***Storm Water Verification***  
***for***  
***Better Together Animal Alliance***  
***ACE # 22-091***

***January 27, 2023***

## Storm Water Calculation Verification

1/23/2023 Amendment KLS:

# BASIN MAP FOR BETTER TOGETHER ANIMAL ALLIANCE

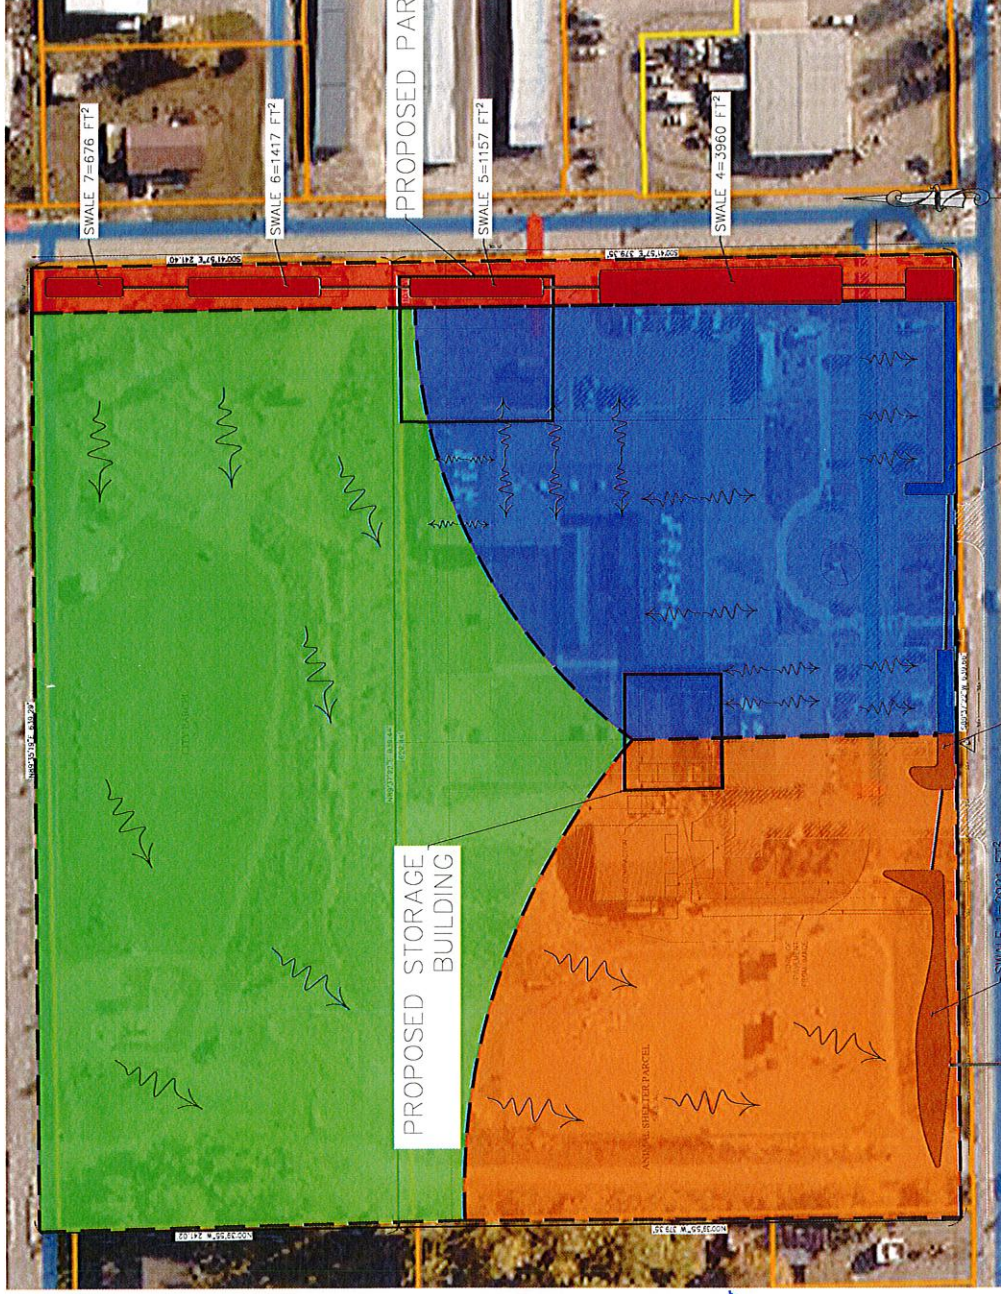
I used the Plan Sheet C-100 from ALSC (Existing Survey Sheet) to start from scratch with a scale of 30, I found several property distance call outs and constructed a brand-new basin map for all 4 predeveloped basins. I did several iterations to ensure I had a more representative basin map that was constructed with property line call outs being used for constant checks.

With the combined parcels yielding of 9.02 acres (392,911 ft<sup>2</sup>) my new assessment of the 4 Basins resulted in an overage of 2376 ft<sup>2</sup> which is 0.06%. This is an area the size of 48.74' x 48.74', a much more acceptable difference.

I also checked the swale sizes that are shown on the plans starting with the one at the SW most part of the project. I tabulated the swales areas in a counterclockwise direction ending up at the NE most part of the site. The measurements listed per each swale were used in the calculation.

My calculations revealed that ACES total swale area resulted in a total of 13,537 ft<sup>2</sup> which is a total swale bottom area of 913 ft<sup>2</sup> ~ 6.32% smaller. I find it peculiar that all the stormwater swales are situated at the south and east sides of the site. The Existing North Basin area is almost half of the project area yet has no swale at or near its location and the stormwater is conveyed to the most southwest area of the site. The proposed parking lot at the east area of the site has a swale just to the east. This proposed parking lot has ample treatment capacity at swale #5. Additionally, the proposed storage building at the heart of the (BTAA) campus straddles the Existing West Basin and Existing East Basin. When the final calculations were performed,
